Squeegee Replacement Kit

Models: T300, T300e, Speed Scrub 300 and A300

Original Squeegee Lift Bracket Design

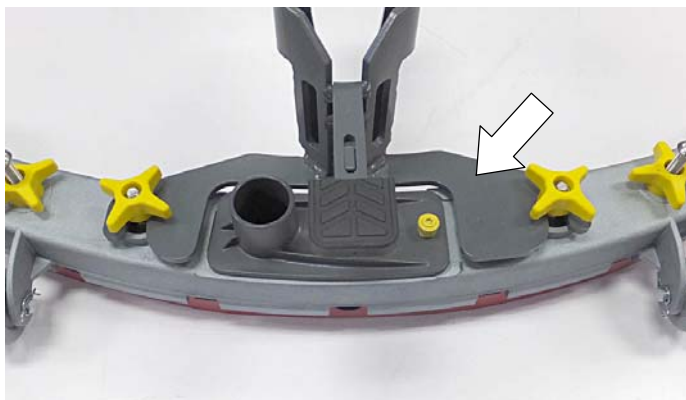
ATTENTION: This new squeegee replacement kit is designed for the latest squeegee lift bracket design. If machine is equipped with the original squeegee lift bracket design, shown below, install the knurled drip trap knob (supplied with kit) as described.

Remove the large drip trap knob from squeegee frame and install the knurled knob on drip trap cover.

The knurled knob provides clearance for squeegee lift bracket engagement as shown below.

To update the original squeegee lift bracket to the latest design, order kit part number 9016194.
